PLANNING BOARD REPORT PORTLAND, MAINE

Ten Unit Townhouses
70 Anderson Street
Level III Subdivision and Site Plan Review
2016-099
Redfern Properties, LLC, Applicant

Submitted to: Portland Planning Board: Public Hearing Date: September 27, 2016	Prepared by: Shukria Wiar Date: September 23, 2016
---	---

Figure 3: 70 Anderson Street Site Plan

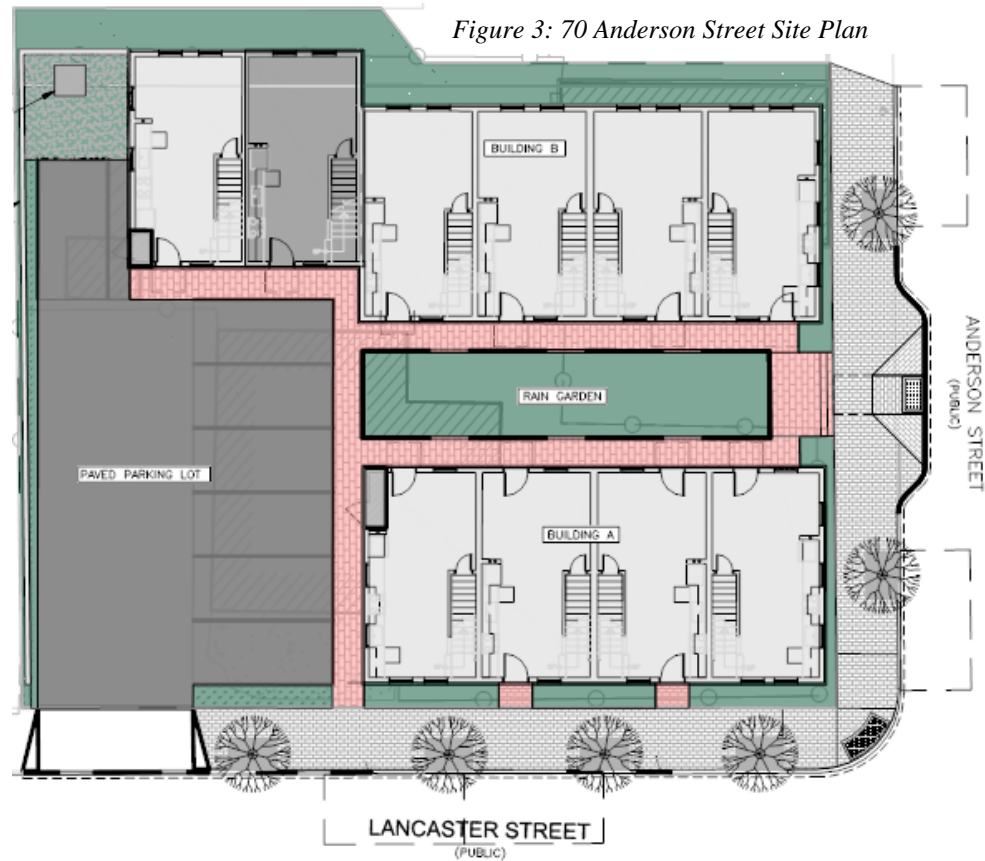
The site will be accessed by an existing curb cut on E. Lancaster Street. The circulation for the site will consist of vehicles pulling in and backing out onto E. Lancaster Street. After reviewing the site plan, there may be opportunity for the first three parking spaces along the street, to maneuver so they can pull out of the parking lot instead of backing out. Tom Errico, P.E. Ty Lin reviewed this detail and also reviewed the proposal's details including the access, parking, and vehicle circulation (Attachment 1). The proposed project is not anticipated to cause unreasonable traffic congestion. Mr. Errico finds the project to be acceptable and states:

- *Given low trip generation estimates for the project, a traffic impact study is not required. The project would not be expected to have a significant impact on traffic mobility and safety.*
- *The parking layout will likely require vehicles to back out into East Lancaster Street. Given low traffic volumes on East Lancaster Street and low trip generation from the site, I find this condition to be acceptable.*
